Government of India - Ministry of Railways
Research, Designs & Standards Organization,
LUCKNOW – 226011

No. EL/0.1.3/Driver

Sub: Amendment no. 01 to Specification no. RDSO/2015/EL/SPEC/0118, (Rev.01) titled as 'Crew Voice & Video Recording System for Electric & Diesel Locomotives.'

Connection Scheme of sub systems of CVVRS

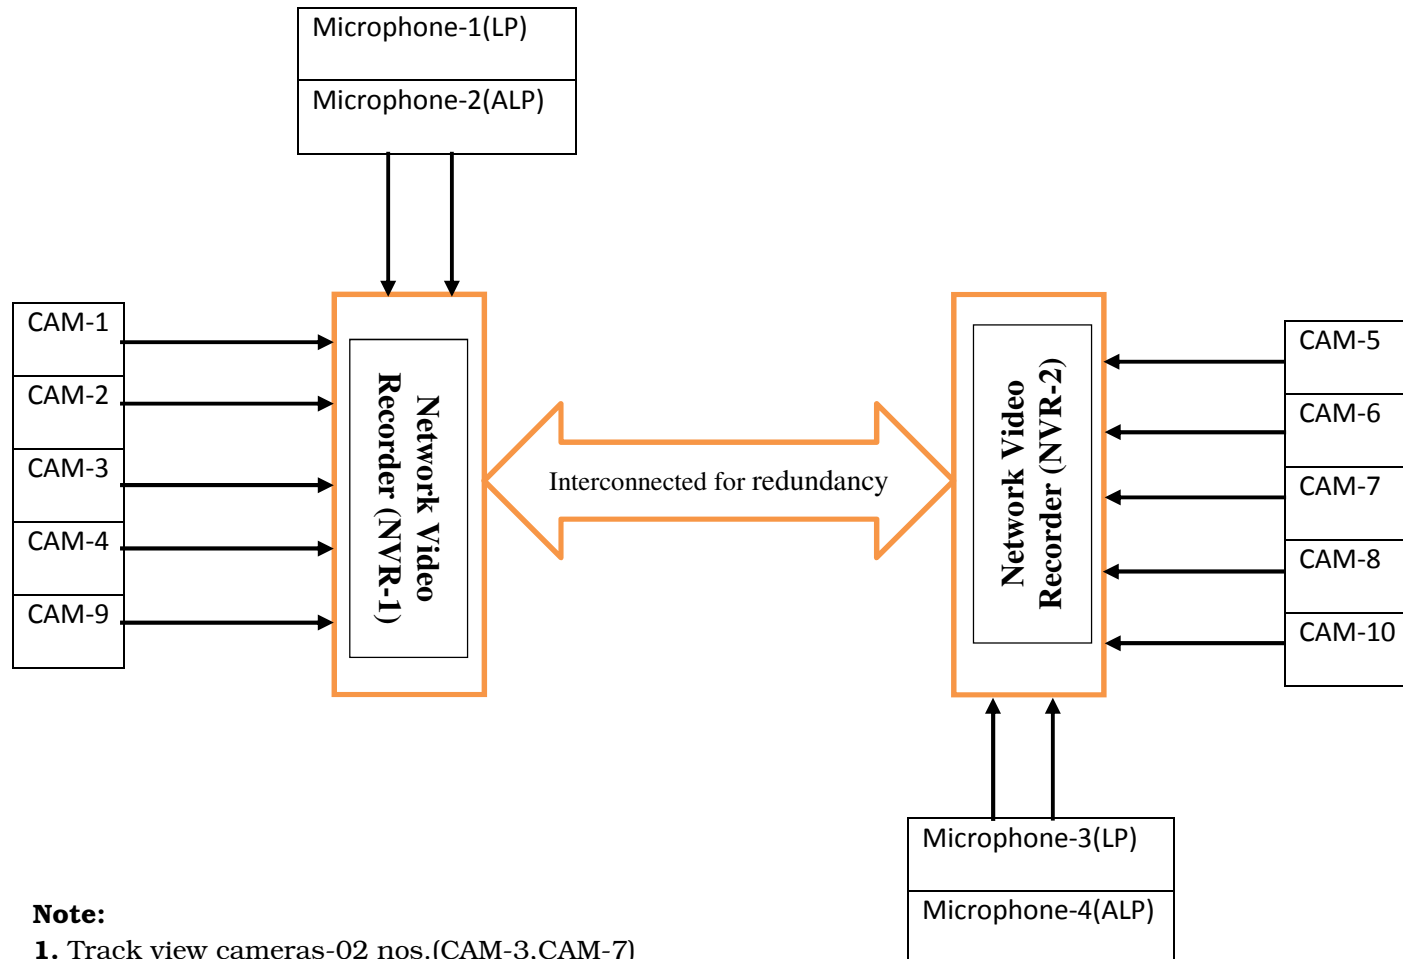
- **Clause 1.1:** Delete the text "2G/3G/" & " 2nd, 3rd & "
- **Clause 2.0: Brief Description of the Equipment**
 - The Para "Network Video Recorder.....Diesel Locomotive" should be replaced as "Network Video recorder with processing system and data storage capable of receiving standard RTSP stream from connected IP cameras & microphones. Minimum Direct 8 channel NVR shall be provided in each cab of electric Locomotive and Diesel Locomotive and both NVRs should work in redundant mode and should be capable of recording either cab. The tentative interconnection scheme of NVRs is given under Annexure-I."
 - **Add new Para in the last of the paragraph.** "• Separate flush type, screw mounted compact size microphone (02 nos.-one each in front of LP/ALP) shall be used to record the voice conversation of crews in the cab & suitably mounted on driver desk for clear voice recording."
